TITLE:	Hardware Modification for AD32 Air Data Display (HIRF compliance according to JAA INT/POL/27&29/1)
DOCUMENT NUMBER:	SB AD32/06
EQUIPMENT:	AD32 Air Data Display
© Copyright by THOMMEN AIRCRAFT EQUIPMENT AG, CH-4132 Muttenz, Switzerland

SB AD32/06

This document is issued to provide information about the hardware change for a higher HIRF protection (in accordance with JAA INT/POL/27&29/1).

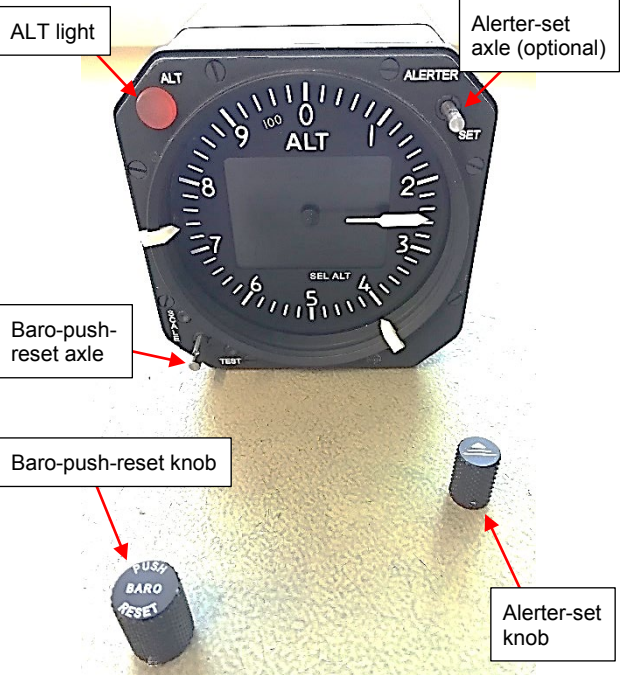
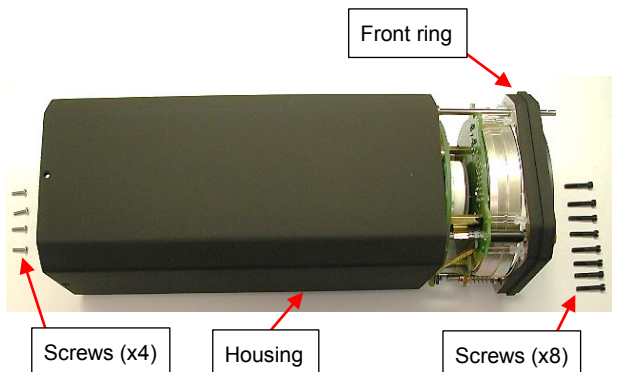
STEP	PICTURE	PROCEDURE
1		<p>NOTE: The AD32, HW 4.10, can be either with or without an ALT light. The AD32, HW 4.10, can be either with or without an alerter-set knob. This procedure is the same for all variants.</p> <p>Remove the grub screw from the baro-push-reset knob, then remove the knob from the axle.</p> <p>If installed, remove the grub screw from the alerter-set knob, then remove the knob from the axle.</p> <p>Clean the two knobs and grub screws.</p>
2		<p>Remove the lead seal from one of the eight screws in the front ring.</p> <p>Remove the eight screws from the front ring.</p> <p>Remove the four screws from the rear of the housing.</p> <p>Remove the housing from the main assembly.</p> <p>Discard the housing.</p> <p>Clean the 12 screws.</p>

STEP	PICTURE	PROCEDURE
3	<p>Lighting PCB</p> <p>Springs (x2)</p> <p>Front ring assembly</p>	<p>Carefully pull the front ring assembly to disconnect it from the lighting PCB.</p> <p>Remove the front ring assembly and the two springs (for the scale and test buttons).</p> <p>NOTE: The AD32, HW 4.10, can be either with or without a scale button. This procedure is the same for both variants.</p>
4	<p>Main assembly</p> <p>Centering ring</p>	<p>Carefully pull the centering ring from the main assembly.</p> <p>Discard the centering ring and its O-ring.</p>
5	<p>Centering ring</p> <p>O-ring cord</p>	<p>Press the new O-ring cord (230mm long) in the groove of the new centering ring.</p> <p>Cut the O-ring cord to the correct length, if necessary.</p>

STEP	PICTURE	PROCEDURE
6		<p>Press the new centering ring on the main assembly.</p> <p>Make sure that the recess at the bottom of the centering ring aligns with the recess next to the lighting PCB.</p>
7		<p>Remove the glass assembly from the front ring assembly.</p> <p>Discard the glass assembly.</p>
8		<p></p> <p>CAUTION: DO NOT CLEAN THE GLASS WITH CHEMICAL SOLVENTS. DAMAGE TO THE COATINGS OF THE GLASS CAN OCCUR.</p> <p>Put the new glass assembly in the front ring assembly.</p> <p>Make sure that the black part of the glass assembly is towards the front face of the front ring assembly.</p> <p>Make sure that the two holes in the white part of the glass assembly align with the LEDs on the front ring assembly.</p> <p>Make sure that the glass is clean from dirt, dust and fingerprints.</p>

STEP	PICTURE	PROCEDURE
9		<p>Put the spring(s) on the push-button axle(s) of the front ring assembly (for the scale (optional) and test buttons).</p> <p>NOTE: The AD32, HW 4.10, can be either with or without a scale button. This procedure is the same for both variants.</p> <p>Make sure that the contact pins on the lighting PCB are not bent.</p> <p>Carefully attach the front ring assembly to the lighting PCB. Make sure that the contact pins connect correctly to the LED connectors.</p>
10		<p>NOTE: The AD32, HW 4.10, can be either with or without an alerter-set knob. This procedure is the same for both variants.</p> <p>Partially put the main assembly in the housing, as shown in the photograph.</p> <p>Push the contact spring(s) in the gap between the axle(s) and the housing.</p> <p>The contact spring(s) must make a good contact with the axle(s).</p> <p>Press the main assembly fully in the housing.</p>

STEP	PICTURE	PROCEDURE
11		<p>Apply Loctite 243 to the screws before assembly.</p> <p>Attach the front ring to the housing with the eight screws.</p> <p>Install the four screws at the rear of the housing.</p>
12		<p>Push the baro-push-reset knob on the bottom axle.</p> <p>Make sure that the hole for the grub screw aligns with the hole in the axle.</p> <p>Apply Loctite 243, then install the grub screw.</p> <p>Push the alerter-set knob on the top axle (optional).</p> <p>Make sure that the hole for the grub screw aligns with the hole in the axle.</p> <p>Apply Loctite 243, then install the grub screw.</p>
13		<p>Print a new MOD status label with the HW MOD status incremented (all other information is unchanged).</p> <p>Print a new identification label (all information is unchanged).</p> <p>Attach the new labels to the new housing as shown in the photograph.</p> <p>NOTE: The photograph shows only typical identification labels. Do not copy the information shown.</p>
